Model: Aries-C1.5	Date: 04-Oct-10	No.: RD095001h
-------------------	-----------------	----------------

Subject: Firmware Release Note: Engine		Prepared by: T. Miyamoto	
From: 1st PP Tech Service Sect., PP Tech Service Dept.			
Classification:	<input type="checkbox"/> Troubleshooting	<input type="checkbox"/> Part information	<input type="checkbox"/> Action required
	<input type="checkbox"/> Mechanical	<input type="checkbox"/> Electrical	<input type="checkbox"/> Service manual revision
	<input type="checkbox"/> Paper path	<input type="checkbox"/> Transmit/receive	<input type="checkbox"/> Retrofit information
	<input type="checkbox"/> Product Safety	<input checked="" type="checkbox"/> Other (Firmware)	<input checked="" type="checkbox"/> Tier 2

This RTB has been issued to announce the firmware release information for the **Engine**.

31.Toner Supply 4

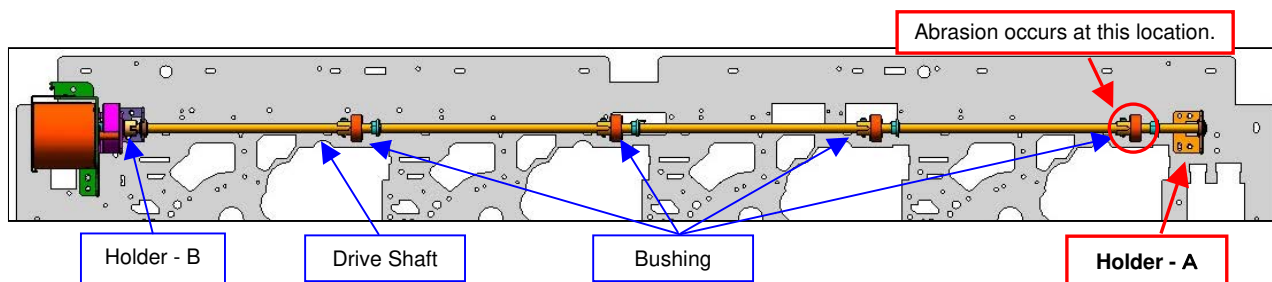
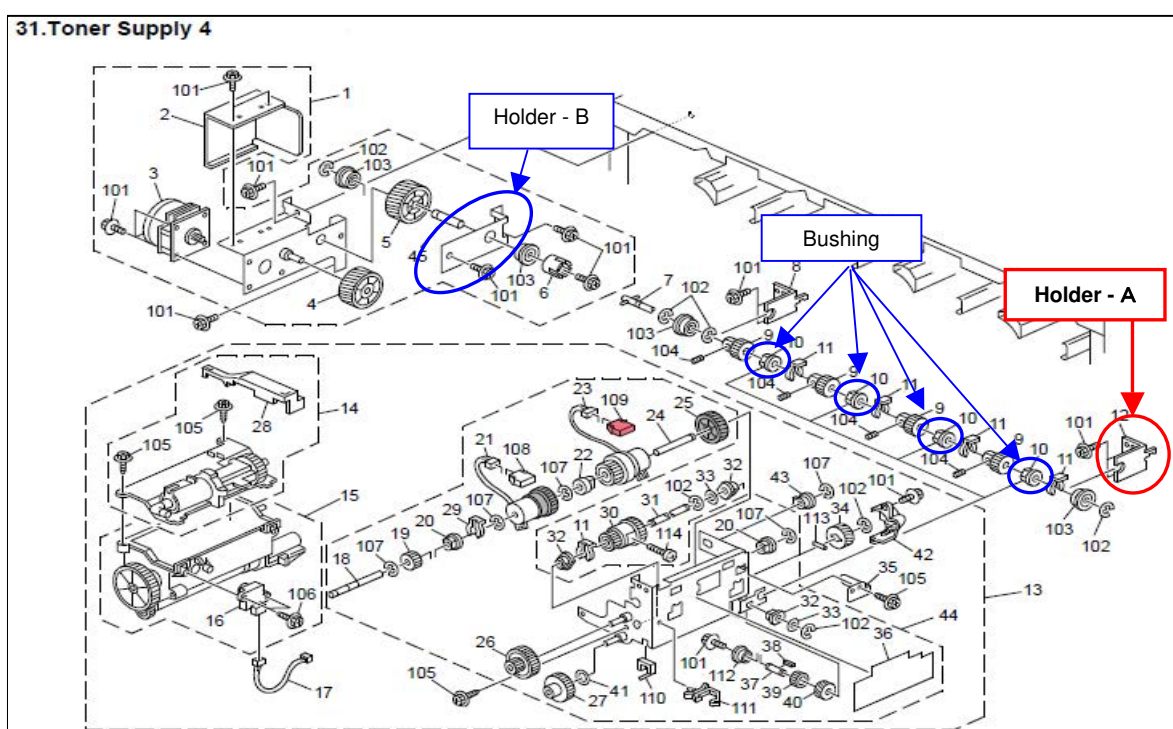
SC328 (Toner supply motor error)

Variations in the precision of assembly of the bushing/holders that fix the sub-hopper units' drive shaft apply stress and causes wear on the drive shaft. (Abrasion of the drive shaft occurs at the bushing closest to "Holder-A".)

Please remove "Holder-A" at your next service visit for the affected units (see the next page for the list of affected units).

- The bushings and Holder-B will give enough support to secure the drive shaft. Removal of the Holder-A will not affect the function.
- Removing the Holder-A will prevent further abrasion of the drive shaft and SC328.
- A worn drive shaft can be continuously used and will not affect the function.

Model : LCIT RT5040 (D095)

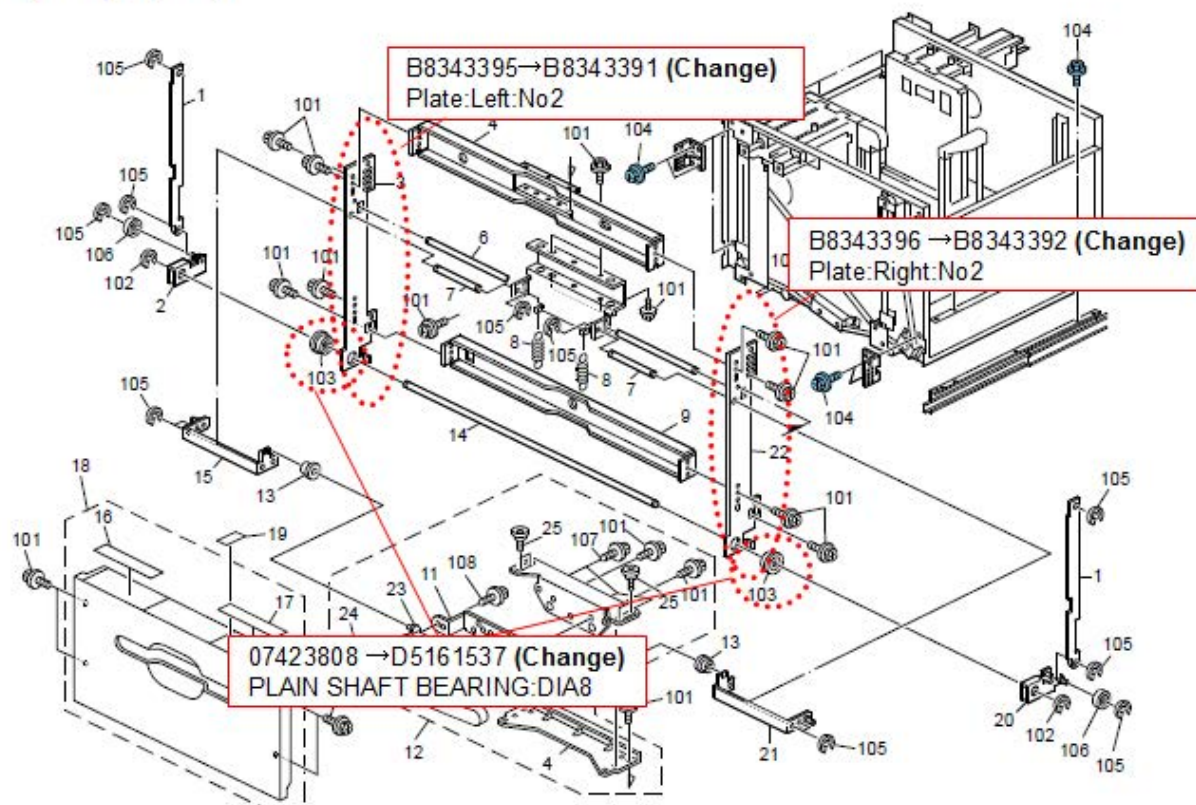
Change: Bearing and the shape of the accompanying plates

2, The size of the holes on the plates were reduced to correspond with the modified bearings.

- **Make sure all 3 parts shown in the above table are replaced as a set.**
- **The modification described in this bulletin also applies to Aegis-C1 (D016), Aries-C1 Lt (D097), LCT RT4000 (D350), LCT RT5020 (D355), and LCT RT5050 (D532).**

103.Exterior 1 (D095)

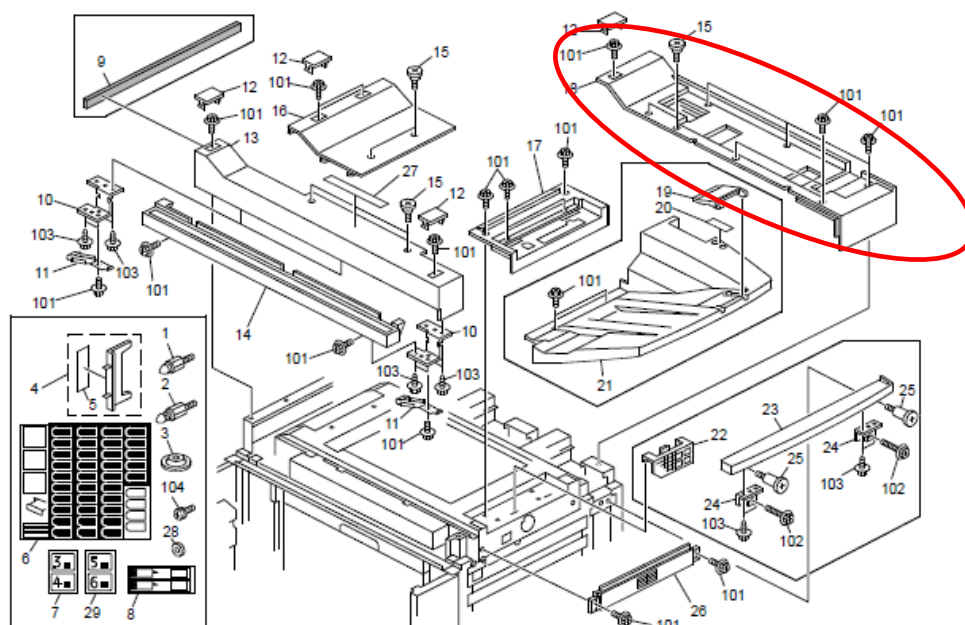
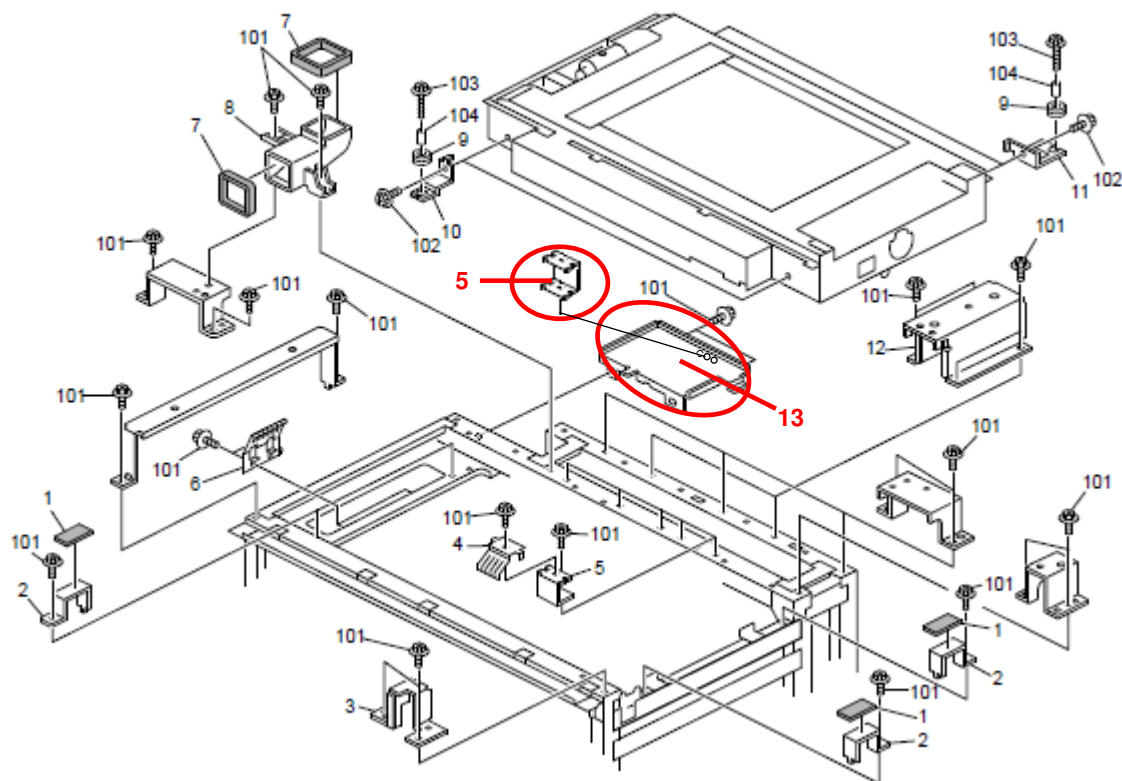
Change: Material of the scanner cover / addition of brackets

*NOTE 1: Interchangeability is X/O as a set.

33.Paper Registration 2 (D059/D060/D061)

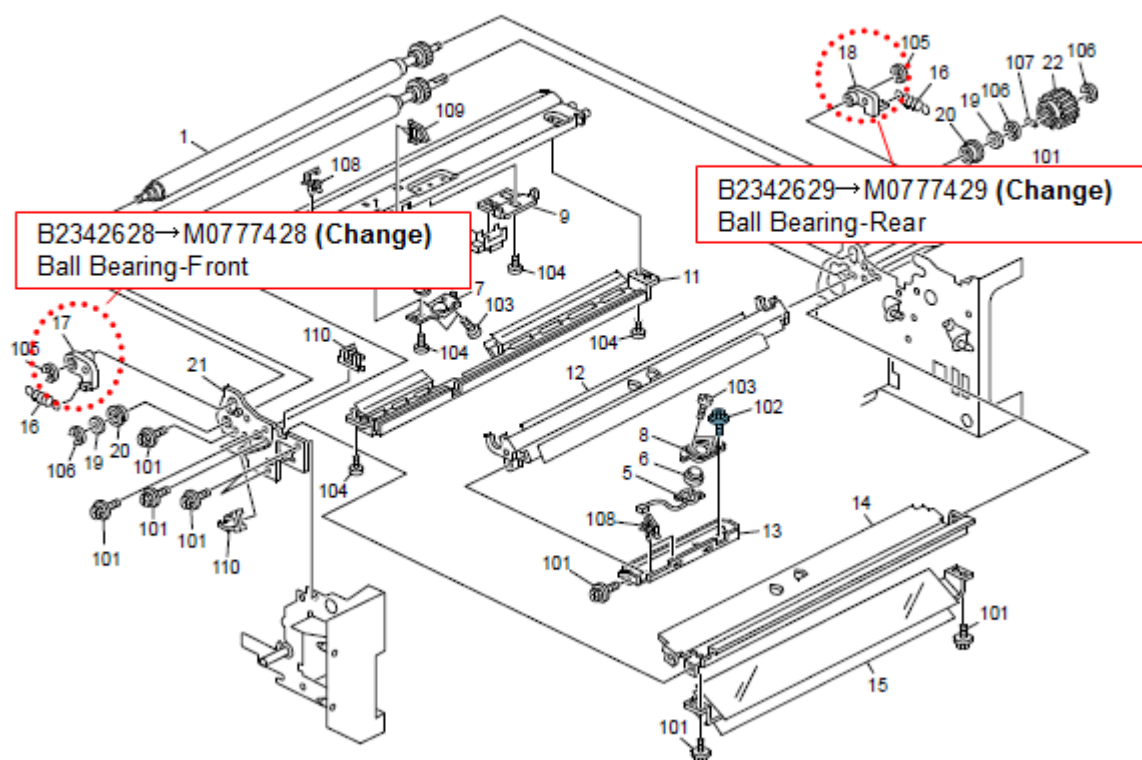
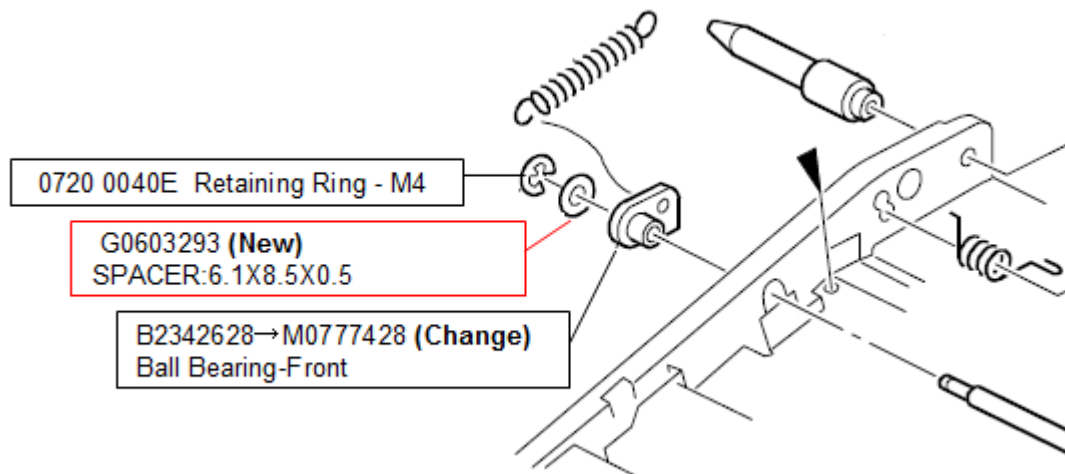
Change: New ball bearings

NOTE: When replacing the above parts, replace all 3 parts as a set.

114.ADF 9 (D095)

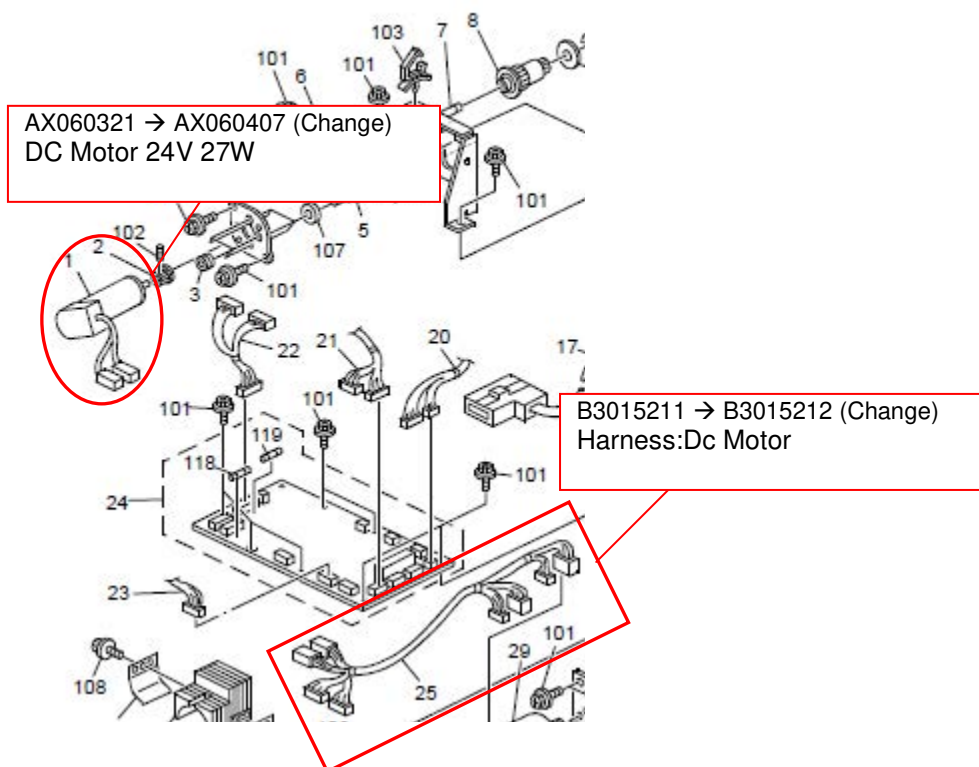
Change: Motor and harness

NOTE: Motor and Harness need to be replaced as a set.
 Motor and Harness interchangeability is X/X individually, and O/O.as a set.
 This change has been applied from 2011 November production.
 This change is also applied to ProC900S, ProC720S
